SERVICE BULLETIN SPSB008

SUBJECT: RELEASE CABLE TRIMMING

STATUS: MANDATORY INSPECTION

SUN PATH PRODUCTS, INC MAIN CANOPY RELEASE HANDLES (PART NUMBER JP068-1) DELIVERED WITH SYSTEMS WITH DATE OF MANUFACTURE JANUARY 2009 THROUGH PRESENT (FEB 2013). IF THE DATE OF MANUFACTURE OF THE HARNESS/CONTAINER SYSTEM IS BETWEEN 1/2009 AND 2/2013, THE CABLE LENGTHS MUST BE INSPECTED.

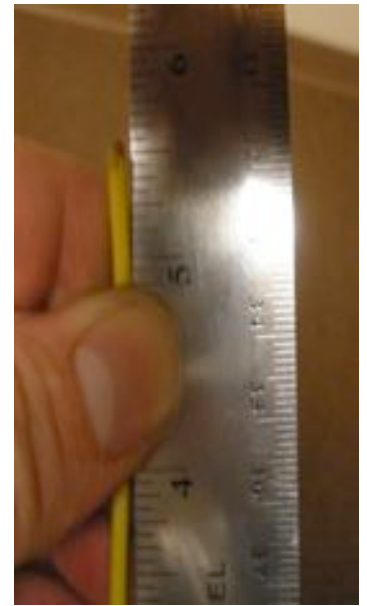
2. Ensure that the release handle is installed; Velcro mated and is all the way up to the top of the inside of the pocket.

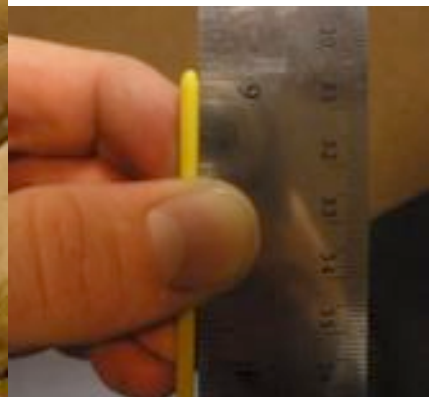
3. Remove any slack in the cables by pulling upward on both sides slightly. (A short tug/or pull on the cable end should take out any slack that may be in the system)
4. Place the rig on the ground or chair and allow the yoke area to relax and ensure your housings are seated/routed as if being worn. Specifically the loop area on the left side behind the main ring cover.
